Architectural Review Committee Staff Report Meeting Date: August 19, 2025

PETITIONER: Integrity Design LLC

PETITION: Shoppes at Brookside Multi-tenant Retail Building Architectural Design

Elevations Submitted by Petitioner

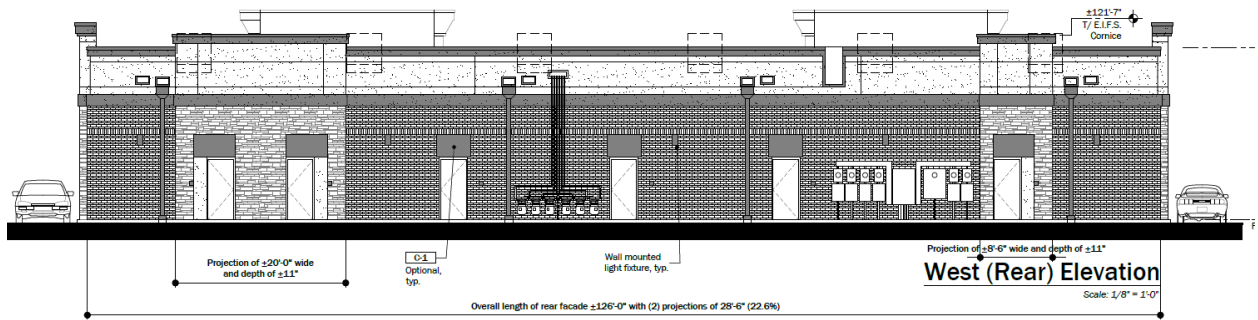
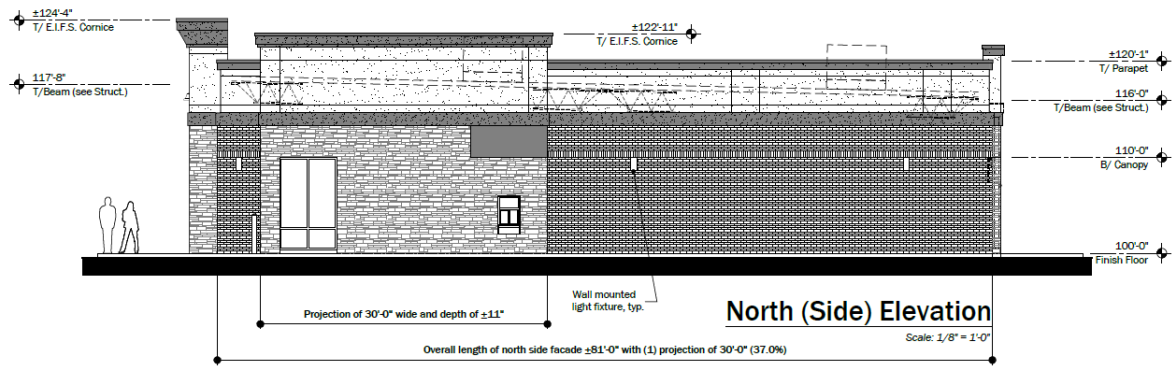
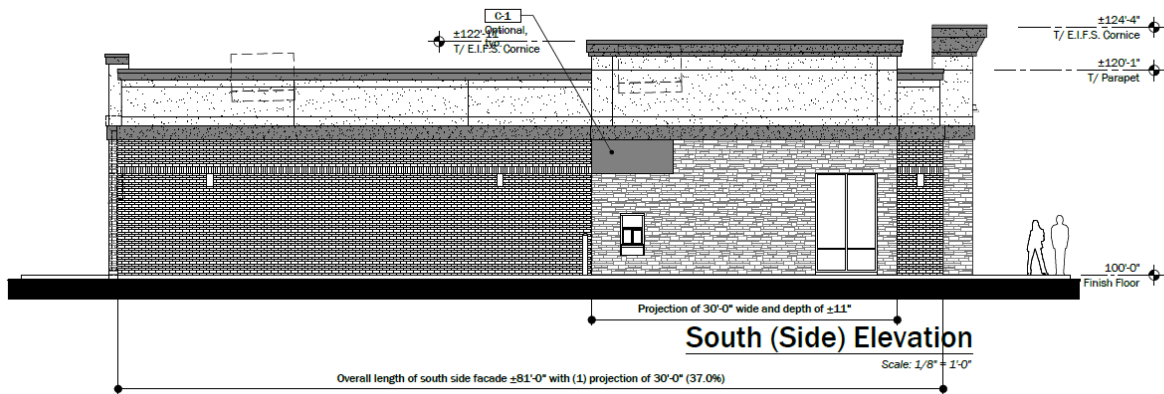
1. **Façade articulation:** The west façade includes articulation but does not meet the overlay's minimum 3-foot depth requirement. *The ARC may approve this as proposed without a Development Standards Variance.* Staff supports the articulation as shown.
2. **Roof articulation:** The PUD requires parapets on flat roofs to align with wall plane articulation. Revised drawings now show parapet articulation on the west elevation that corresponds with wall plane articulation.

3. **Decorative sconces:** The petitioner intends to use the same (or closely matching) sconces as the first building in the development.
4. **Doors & Frames:** The petitioner intends to match the first building's dark bronze aluminum frames, storefront doors, and glazing system.
5. **Exterior materials and colors:** Staff is continuing to work with the petitioner to finalize a color scheme that better aligns with the development's overall aesthetic. Updated samples will be presented at the meeting.

- Request verbal confirmation from the petitioner on items #3-5 above.
- Provide specific comment on Item #1 (west façade articulation).
